**FEDERAL FACILITY AGREEMENT AND CONSENT ORDER (FFACO)
RECORD OF TECHNICAL CHANGE (ROTC)**

Document Type Frenchman Flat Five-Year Evaluation **Date** 05/24/2023

Corrective Action Unit 98: Frenchman Flat Five-Year Evaluation Nevada National Security Site, Nevada

**NEVADA ENVIRONMENTAL MANAGEMENT OPERATIONS ACTIVITY
DOCUMENT REVIEW SHEET**

Figure 1-1
FF Groundwater Sampling Locations

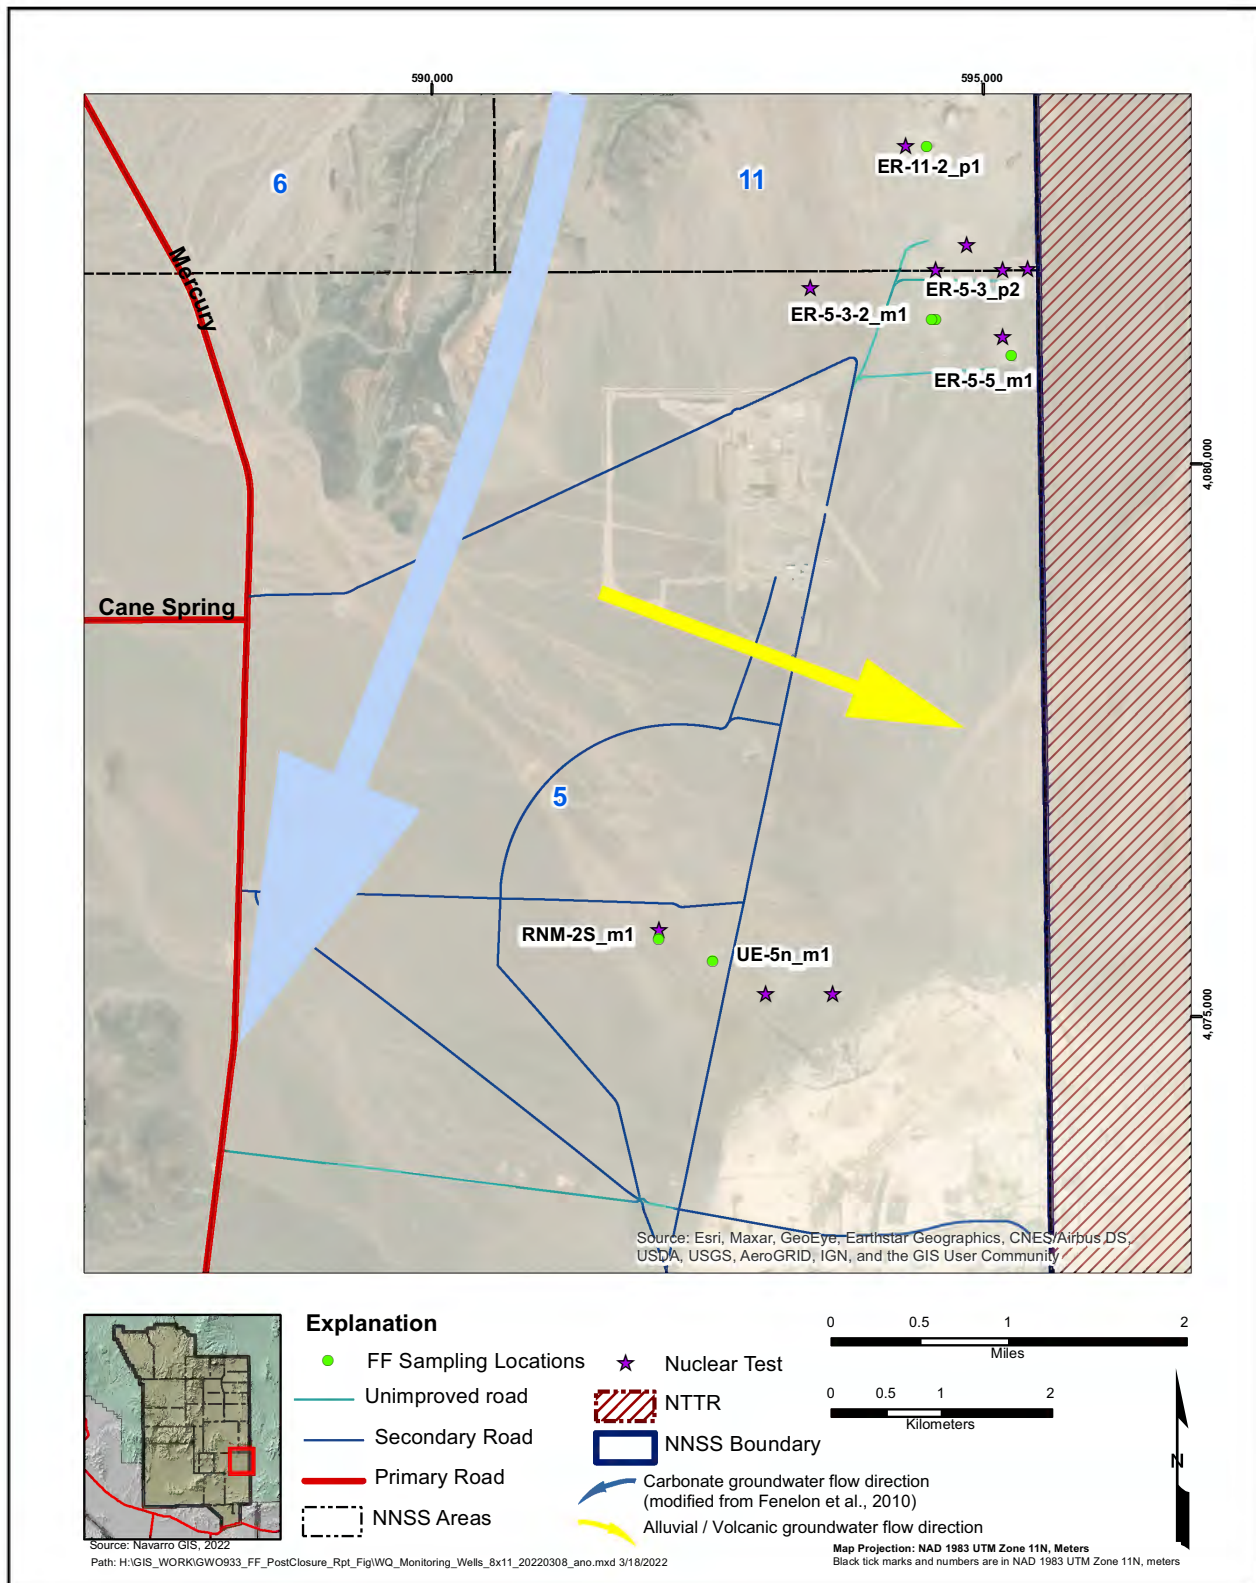
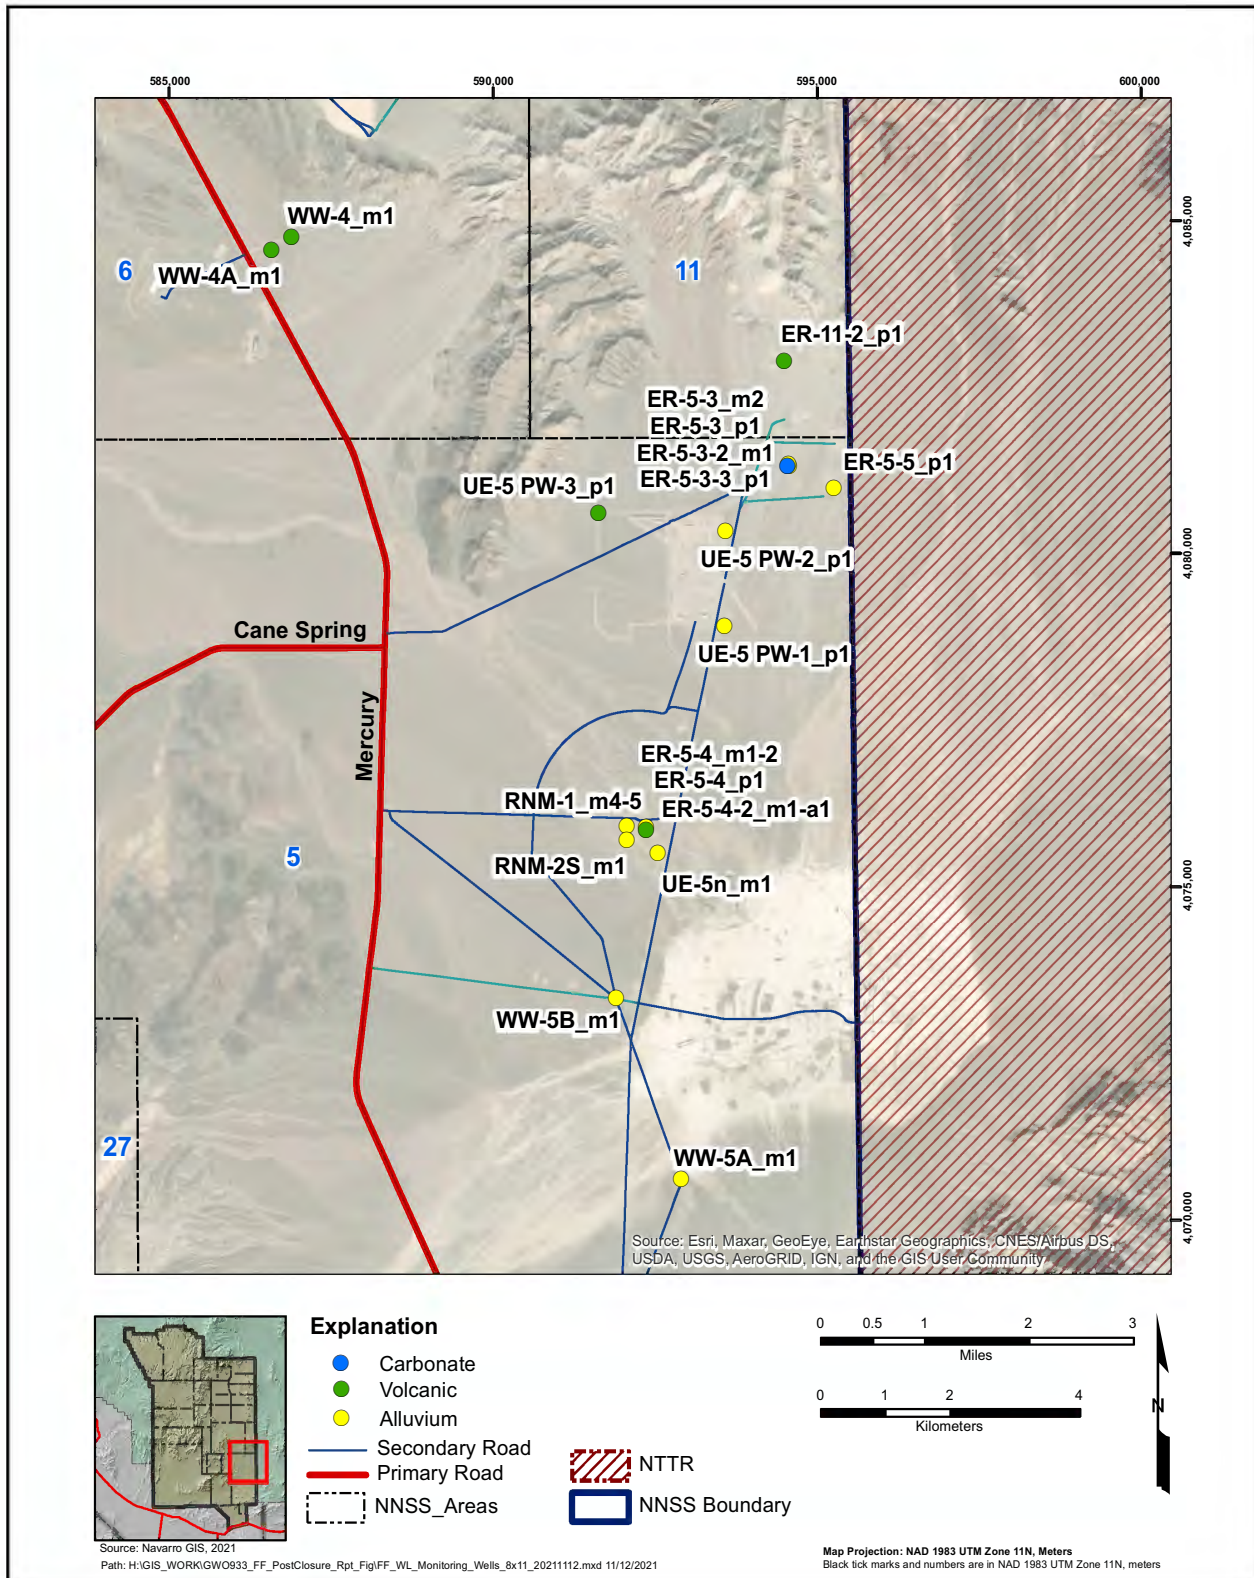
2.	Section 1.0	Please include a Figure showing the groundwater flow direction(s), the locations of underground detonations, and the sampling/water level monitoring locations.	Figure 1-1 has been revised to show the sampling locations, underground detonations, and groundwater flow paths (carbonate and volcanic/alluvial) as requested. Figure 1-2 shows the water-level monitoring locations.

Figure 3-21
Water Levels in ER-5-3-2_m1

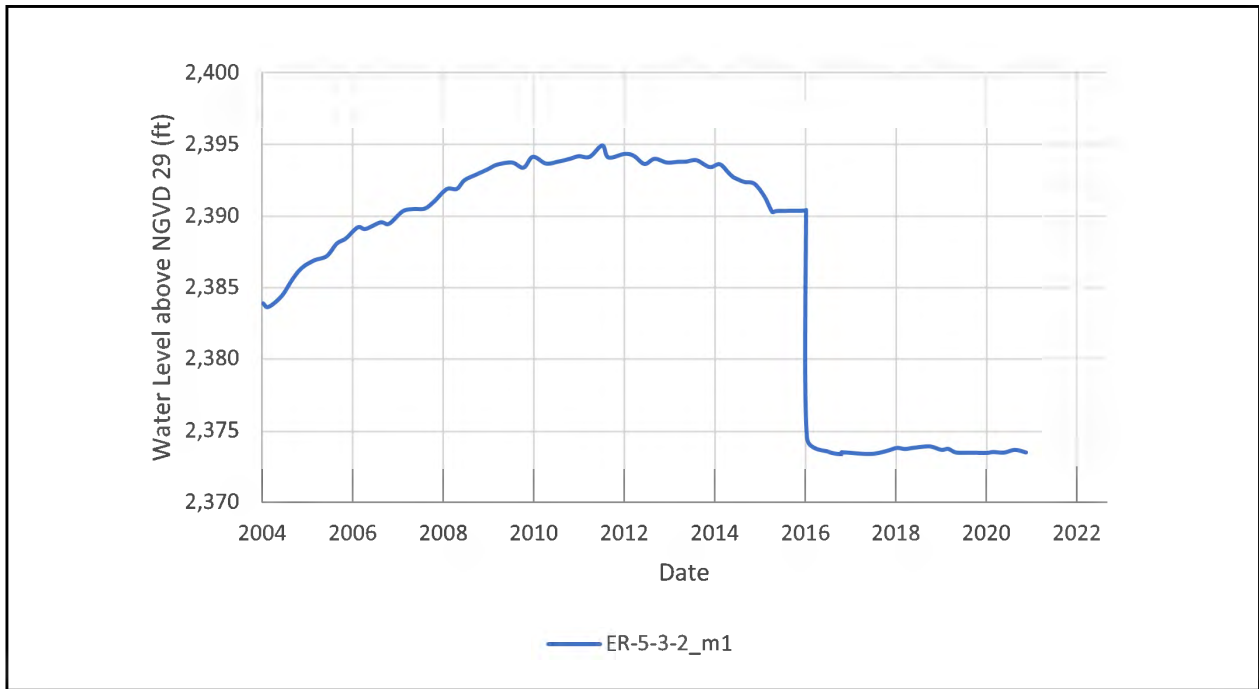
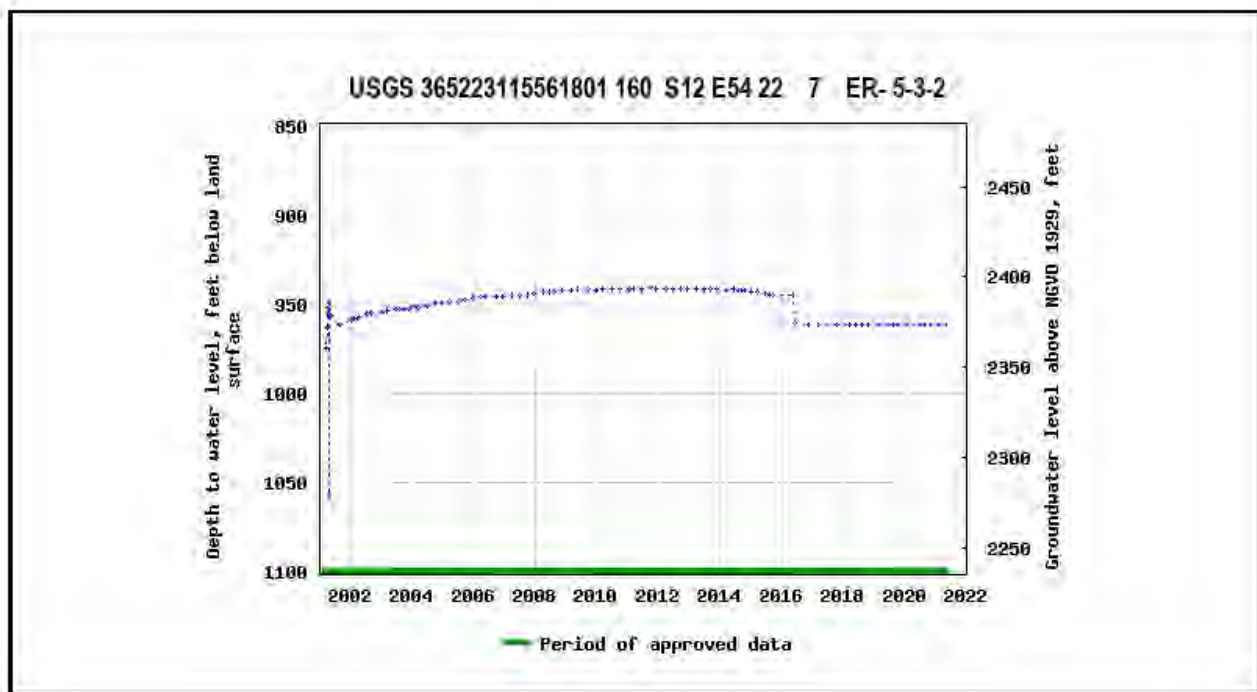
10. Comment Number/Location	11. Type ^a	12. Comment	13. Comment Response
6.		In regard to Well ER-5-3-2_ml, it is stated on Page 20 that "This well experienced a rapid drop in water level in 2016 after pumping, and the water-level trend has continued at the now steady value since 2016. The cause of the sudden drop in water level is unknown but does not appear to be related to natural changes in LCA water levels." In the Calendar Year 2020 Annual Closure Monitoring Report for Corrective Action Unit 98: Frenchman Flat, Underground Test Area, Nevada National Security Site, Nevada (January 2020-December 2020, Revision 0, June 2021 (ACM) in regard to the same well, it was stated in Section 6.2 that, "This well experienced a mechanical problem in 2016 following pumping... This change in water level is believed to be the result of a well construction problem..." The ACM also stated in Section 6.3.1 that the mechanical failure called into question the integrity of the well. What investigation has been done to date or why has the cause of the rapid drop in water level in 2016 not been investigated during the ensuing six (6) years to attempt to determine with certainty any problems with this very important, key monitoring well given that it is the sole monitoring well in the regional carbonate aquifer? What is planned for the future and why is the EM NP confident that this is not related to natural changes in the LCA?	<p>The description in the draft report was revised following SME input that suggested more investigation was needed to understand the change in water level. EM Nevada Program initiated a study by USGS to further investigate the water-level changes. The draft study is in SME review (submitted to internal reviewers on 03/04/2022) with publication in late CY2022 or CY2023.</p> <p>The investigation evaluated multiple hydrologic, geochemical, and geologic data using several scenarios to explain the abrupt change in water level. While no clear explanation was identified to explain the water-level change, the study confirmed the completion is producing water from the LCA (based on water chemistry) and concludes that the well is a viable LCA sampling location. The report will be updated to recommend continued sampling of ER-5-3-2. As the investigation report is not yet published, the update to this report will not produce details at this time but will acknowledge the investigation.</p> <p>The drop in water level in 2016 was not investigated because the project was at the beginning of the 5-year data collection period, and it was deemed appropriate to complete the data collection to identify any trends. The investigation undertaken by USGS, while not conclusive as to the cause for the water-level change, does support continued sampling of ER-5-3-2 as an LCA monitoring location. No additional investigations are planned at this time.</p> <p>The following was added to the text: "An investigation of the potential cause or causes of the water-level changes in ER-5-3-2_m1 was conducted by USGS. Their findings are documented in a draft report that was undergoing internal USGS and UGTA Activity subject matter expert reviews at the time this five-year evaluation report was prepared. Specific findings will be released when the USGS investigation report is published, but a general conclusion of the USGS investigation is that ER-5-3-2_m1 is a viable sampling location for the LCA in FF based on the similarity of the water chemistry to other LCA water samples in the vicinity."</p>

Figure 3-25
Long-Term Water-Level Trends in the VA Wells WW-4_m1 and WW-4A_m1
Source: USGS, 2021

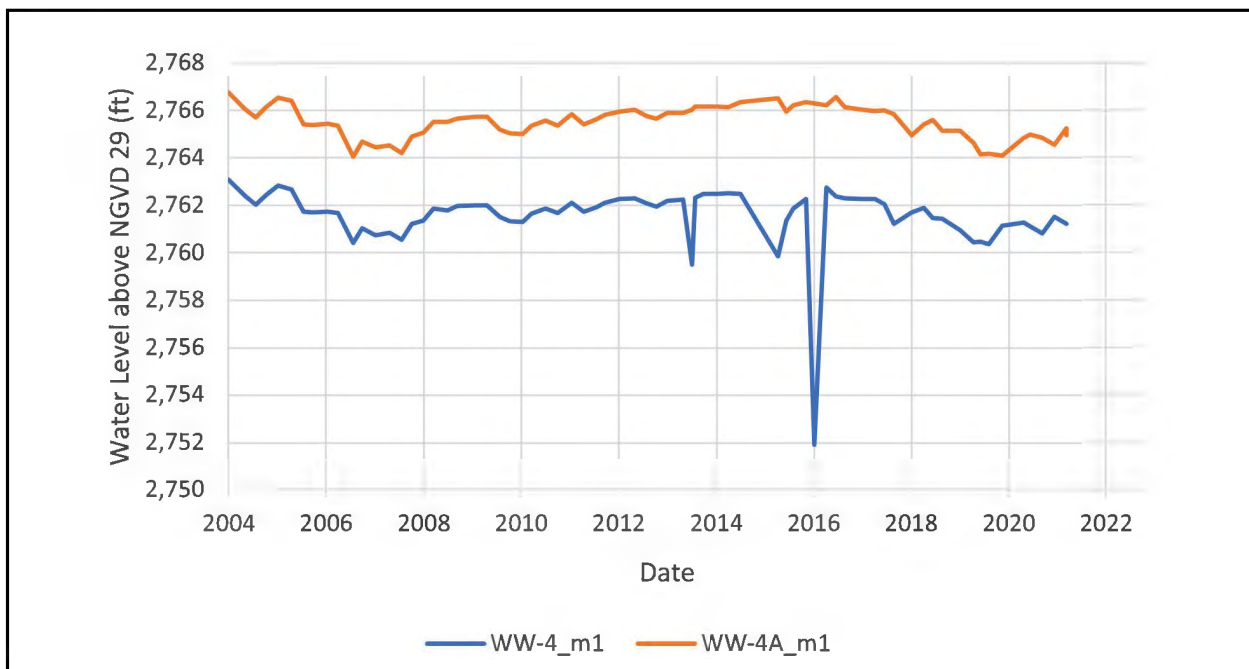
9.	Section 4.2, Page 26, 3 rd Paragraph	Please state why Well WW-4A is being recommended for continuation of water level measuring over Well WW-4.	<p>WW-4A was chosen for two reasons: first, because it has a longer period record; and second, recent measurements are not as noisy as the WW-4 record.</p> <p>Added to paragraph: "Although either well would be acceptable, the recommendation is to continue to report water-level measurements from WW-4A for two reasons: (1) WW-4A has a longer period of record, and (2) recent water-level measurements from WW-4A are not as noisy as the WW-4 water-level measurements."</p>
